# Variance Request Site Plan

V-51  
(2015)

## 5010 Timber Ridge Road

**APPLICANT:** Carol Young **PETITION No.:** V-51  
**PHONE:** 678-404-7796 **DATE OF HEARING:** 04-01-2015  
**REPRESENTATIVE:** Arthur Garrison **PRESENT ZONING:** R-20  
**PHONE:** 404-435-6632 **LAND LOT(S):** 136  
**TITLEHOLDER:** Carol E. Young **DISTRICT:** 1  
**PROPERTY LOCATION:** On the southern side of **SIZE OF TRACT:** 1.09 acres  
Timber Ridge Road, west of Little Willeo Road **COMMISSION DISTRICT:** 2  
(5010 Timber Ridge Road).  
**TYPE OF VARIANCE:** 1) Waive the minimum public road frontage from the required 75 feet to 42.5 feet for lot 2; and 2) waive the front setback for proposed lot 2 from the required 40 feet to 35 feet.

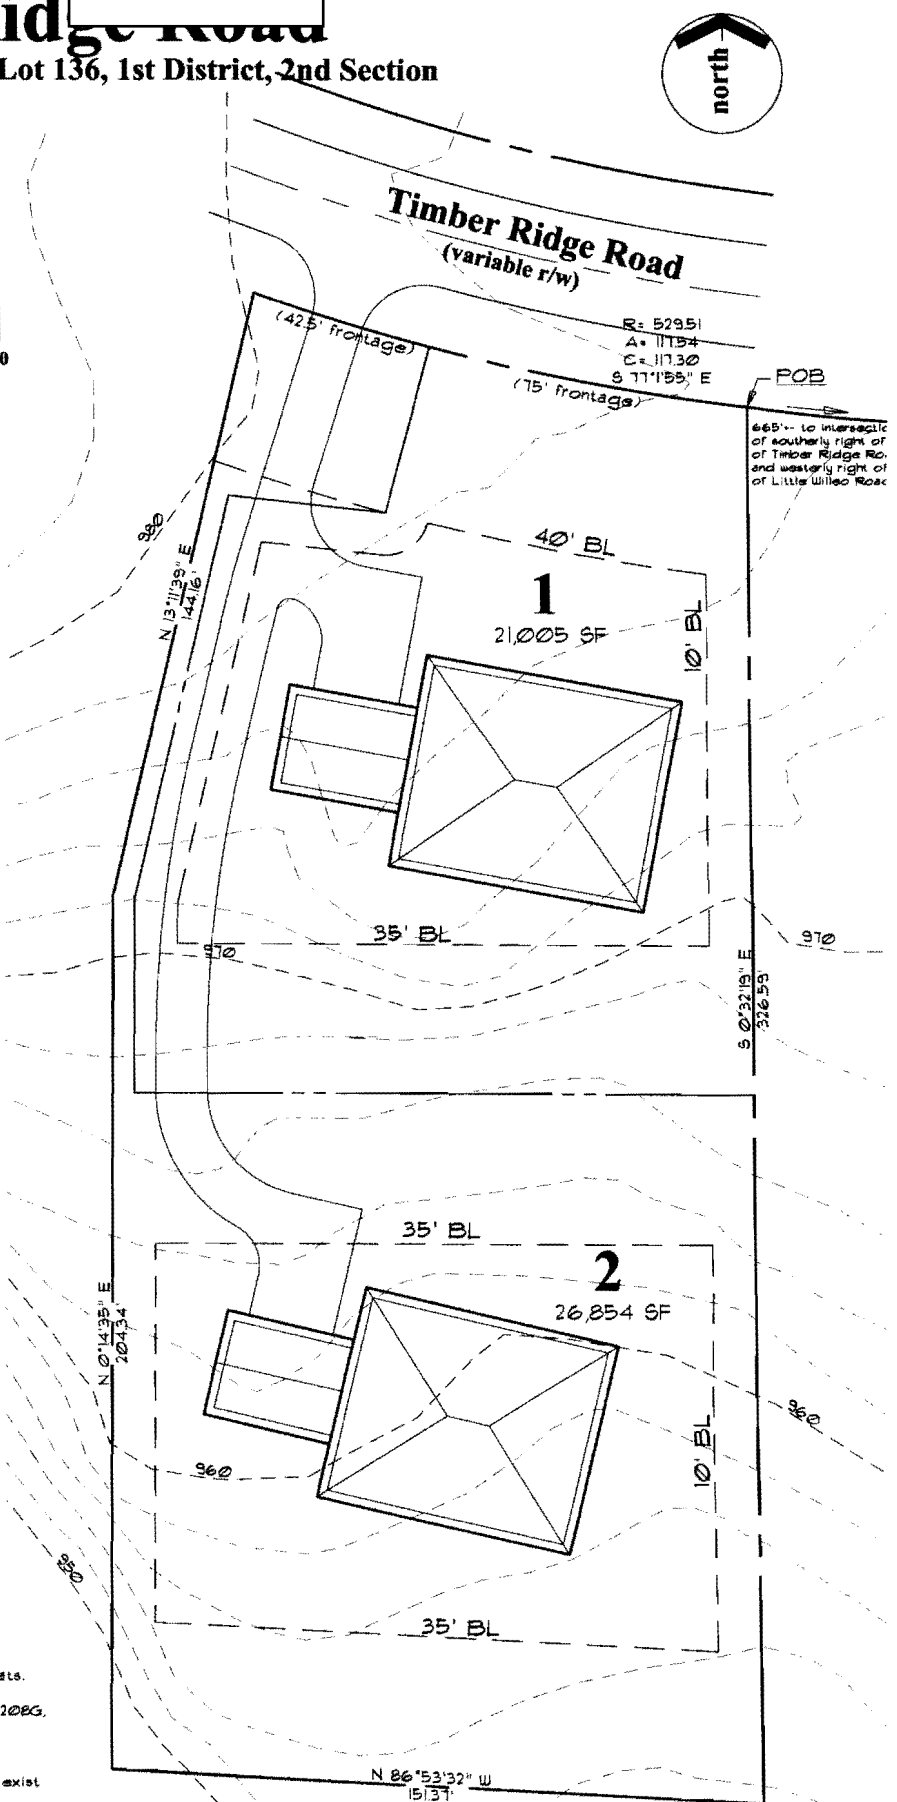
**SITE PLAN REVIEW:** If this variance request is approved, a subdivision plat revision must be recorded prior to the issuance of the certificate of occupancy showing all improvements on the lot and referencing the variance case in the standard plat revision note. The surveyor must submit the plat to the Site Plan Review Section, Community Development Agency for review and approval prior to recording. Call 770-528-2147.

**STORMWATER MANAGEMENT:** There is limited downstream stormwater conveyance from the parcel. If the lot split is approved, building permits should be made subject to Stormwater Management Division approval of onsite runoff mitigation.

- Driveway must have a minimum 12' driving surface width with minimum 25' inside turning radius.
- Fully developed landscaping shall be at least 7'0" from center of drive (14' clear width) and 13'6" vertical clearance. (Indicate on plan minimum setbacks).
- Maximum grade shall not exceed 18%.
- Driveway must extend within 150' of the most remote portion of the structure.
- Driveway is limited to 1000' maximum from roadway unless an approved turn-around is provided. (See note below.)
- Driveway must support 25 Tons (50,000 lbs.)
- Provide emergency access to all gates securing Fire Dept. access with a minimum 12'-0" clear width
- Hydrant within 500' of remote structure, minimum 6" main\*  
( Required Flow: 1000 gpm @ 20 psi)
- Fire Flow Test from closest existing hydrant\*  
(Required Flow: 1000 gpm @ 20 psi)
